Product Change Notification / NTDO-11AIEB760

CCB 5010.001 Final Notice: Qualification of MTAI as an additional assembly site for LAN8710A-EZC-ABC, LAN8710AI-EZK-ABC, LAN8710A-EZC-TR-ABC and LAN8710AI-EZK-TR-ABC catalog part numbers (CPN) available in 32L QFN (5x5x0.9mm) package.

CCB 5010.001
Pre and Post Change Summary
PCN#: NTDO-11AIEB760

ASE

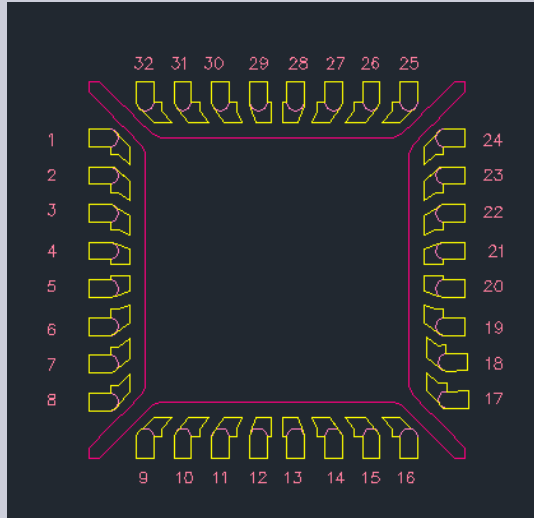
Lead Frame material	A194
Lead Frame Paddle size	138 x 138mils

MTAI

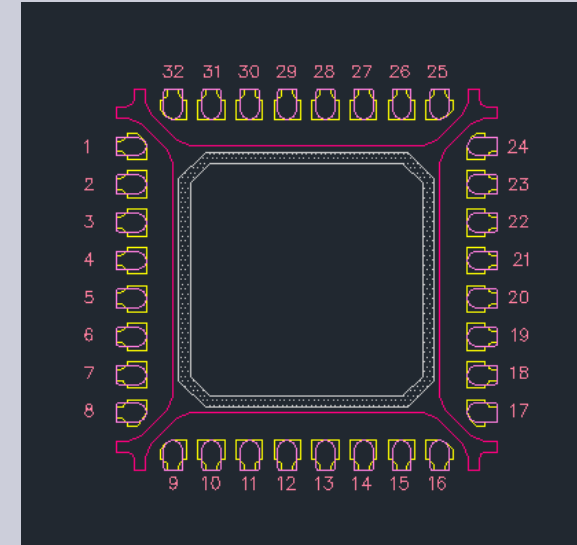
Lead Frame material	A194
Lead Frame Paddle size	169 x 169mils
